**100 Percent Report
Crater Lake Transportation Study**

August 1989

Prepared For:
National Park Service

RESPONSE TO NPS REVIEW COMMENTS

Figure 2. Representative slope profile between lower parking area and Activity Center/Hotel.

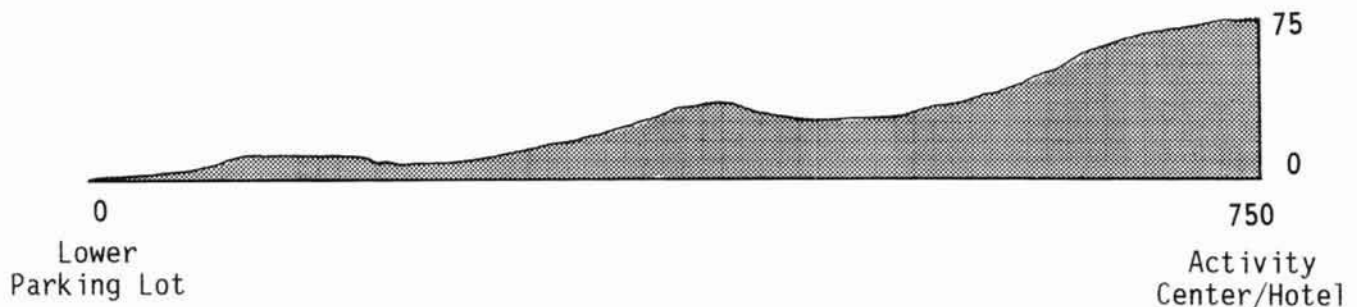
22. *p. 4 - Figure 2. Horizontal and vertical scale would help the meaning of this figure.*

A scale has been added.

Figure 5. Typical winter season daily visitation patterns at Crater Lake.

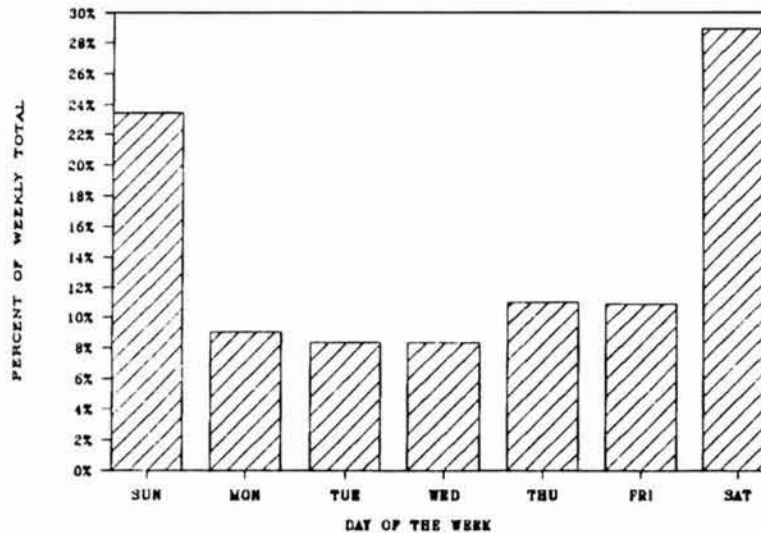
23. *p. 8 - Figure 5. Vertical legend in error?*

29. *p. 8 - Figure 5. Scale of Y axis is incorrect.*

The vertical bars were at the correct relative height, but the vertical legend was in error. A corrected version is shown in the 100% report.

Figure 8. Comparison of visitation at Crater Lake National Park and all National Parks between 1978 and 1987.

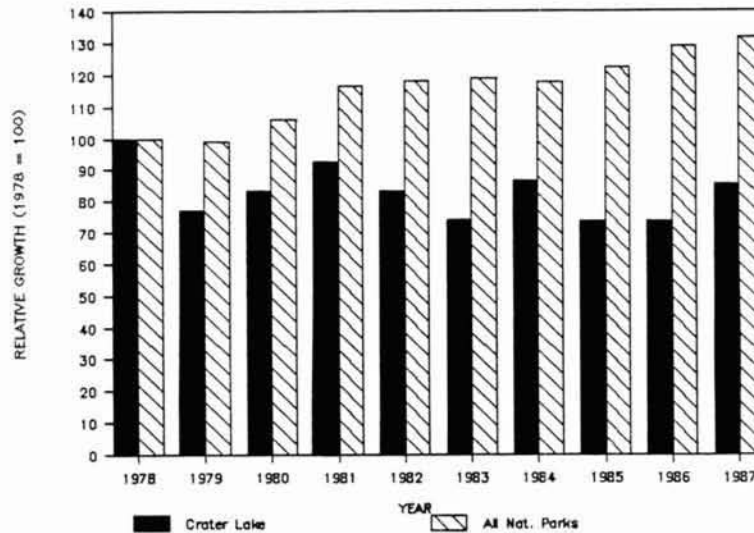
31. *p. 10. The comparison of Crater Lake vs. system-wide visitation is interesting but perhaps confusing. There has probably been an increase in the number of park service facilities since 1978. The change in visits per facility may not be quite as dramatic.*
